Access Compliance Report

Public Rights-of-Way

(Curb Ramps)

Intersection ID: 15001	Main Street: N_DOTGER_AV	Cross Street: VAIL_AV	Location:	N
ADA ID: B274FCFE8A4D	Ramp Type: BlendTrans1	Initial Pass/Fail: Fail	Overall Compliance: No	Severity Score: 25

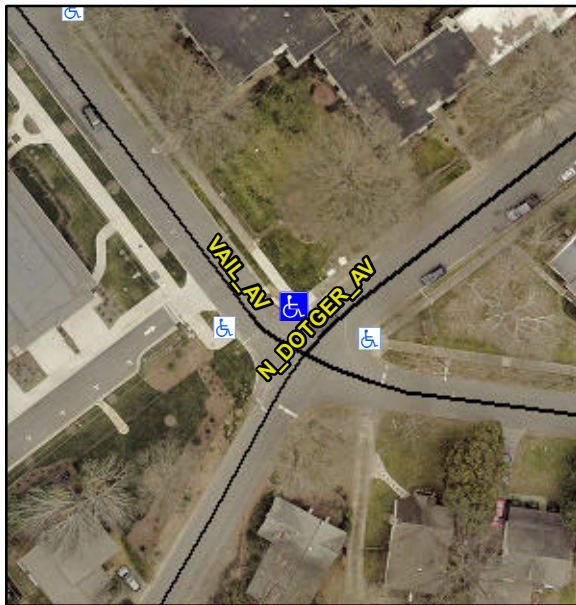
Not Found, R304.5.3

Compliance	Description	Data	Compliance	Description	Data
N/A	Ramp Length (in)	84.0	Yes	BlendTrans Slope (%)	3.0
Yes	Ramp Width (in)	48.0	No	BlendTrans XSlope (%)	9.1
N/A	Flare Type LT	N/A	N/A	Flare Type RT	N/A
N/A	Flare Slope LT (%)	N/A	N/A	Flare Slope RT (%)	N/A
N/A	Flare Traversable LT?	N/A	N/A	Flare Traversable RT?	N/A
N/A	Landing Length (in)	N/A	N/A	DWS Provided?	N/A
N/A	Landing Width (in)	N/A	N/A	DWS Contrast?	N/A
N/A	Landing Slope (%)	N/A	N/A	DWS Length (in)	N/A
N/A	Landing X Slope (%)	N/A	N/A	DWS Full Width?	N/A
N/A	Landing Curb? (Y/N)	N/A	N/A	DWS Offset (in)	N/A
N/A	Shared Landing?	N/A			
N/A	Gutter Ponding?	N/A	N/A	Gutter Slope (%)	N/A
N/A	Gutter Lip Ht (in)	N/A	N/A	Gutter X Slope (%)	N/A
N/A	Painted X Walk1?	No	N/A	Painted X Walk2?	No
	X Walk 1 Direction	To SW		X Walk 2 Direction	To SE
	X Walk 1 Width (in)	N/A		X Walk 2 Width (in)	N/A
	X Walk 1 Slope (%)	4.3		X Walk 2 Slope (%)	1.1
	X Walk 1 X Slope (%)	3.1		X Walk 2 X Slope (%)	3.2

N/A	Ramp inside XWalk1?	N/A	N/A	Ramp inside XWalk2?	N/A
	Road Slope (%)	5.2		Clear Space?	N/A
	Road X Slope (%)	0.7	N/A	Clear Space to XWalk (in)	N/A
N/A	Any Obstructions?	N/A	N/A	Storm Grate/Utility Hazard?	N/A
	Obstruction Type			Storm Grate/Utility Type	
		N/A			N/A
			Yes	Surface Condition? (G/P)	Good
			No	Curb Slope (%)	17.4

Remove & Replace Curb Ramp With Two New Directional Ramps or Equivalent.
